Inter-Office Communication

Subject: **Petition 28COA-99HPB.** Erect lighting for Roper Park located in the 200 block of NE 4<sup>th</sup> Avenue in the Northeast Residential Historic District. City of Gainesville, Owner and Agent.

**Subject:** Lighting in Roper Park

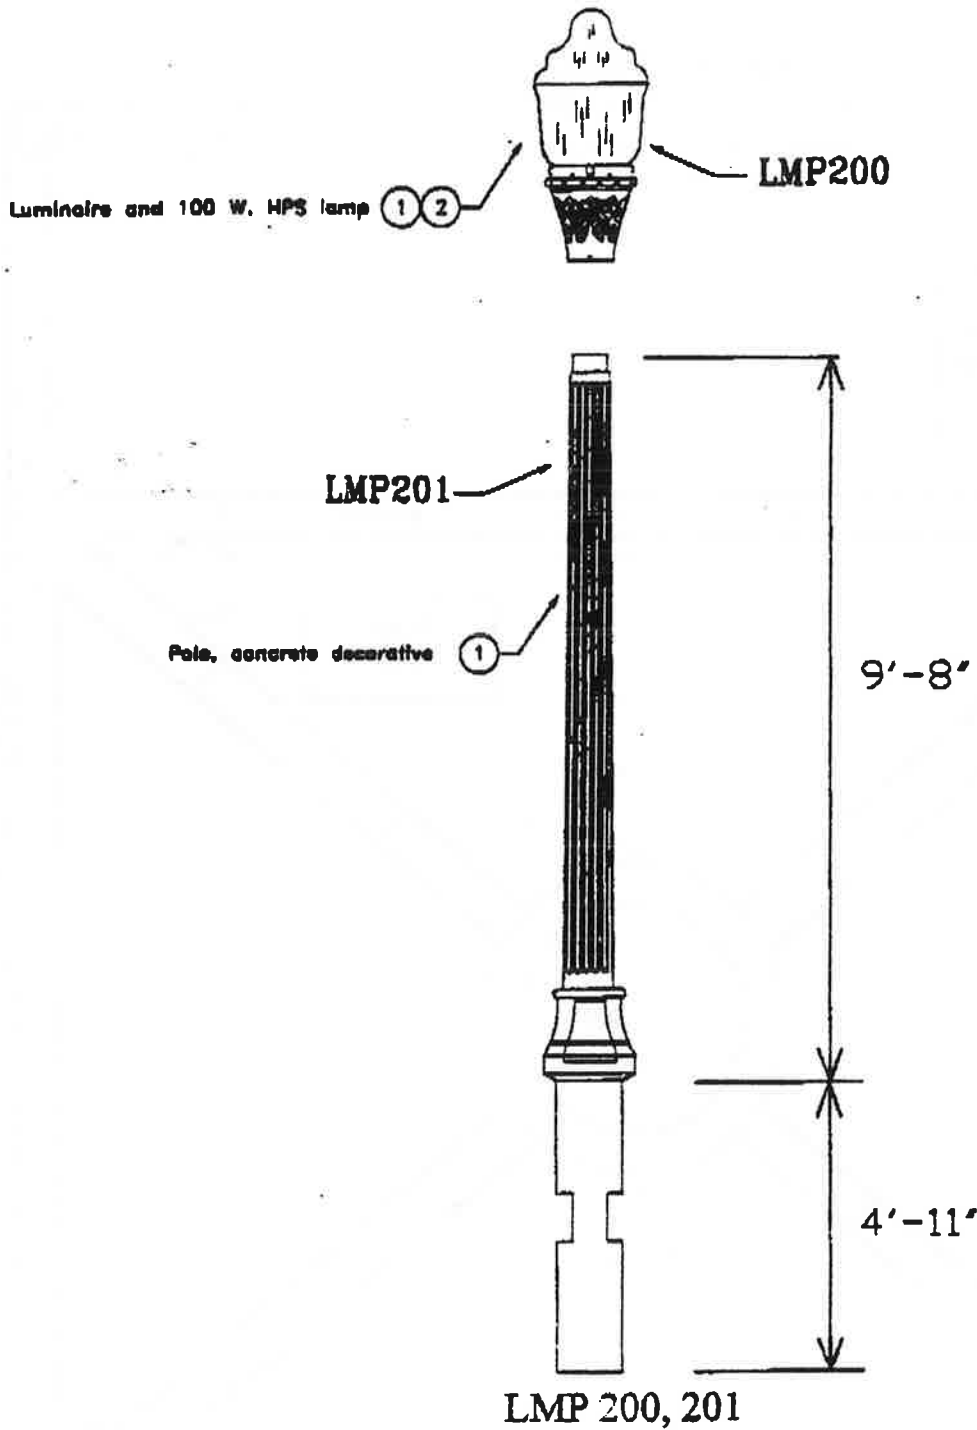
- *The applicant comply with all the applicable codes of the City of Gainesville; and*
- *Relocate the lights in the manner indicated on the attachment.*

- *The proposal complies with the Secretary of Interior's Standards for Rehabilitation and Illustrated Guide for Rehabilitating Historic Buildings because it will not remove or radically change features that define the site, namely the formal quality conveyed by the walkways which center on the azaleas; and*
- *The recommendations to relocate the position of the lamps is designed to provide definition to the corners of Roper Park and focus on its center.*

As it stands, additional lighting is warranted in the area to provide a safer environment for visitors. Special consideration should be given to pedestrian oriented lighting along sidewalks identified as primary routes for pedestrians "cutting through" the park after dark.

It is recommended that any lighting in the park be placed on timers set to turn lights off no later than 11:30PM in accordance with City ordinance 18-19(a) setting forth hours of operation for City parks. It is further recommended that any lights be placed below the tree line for maximum visibility.
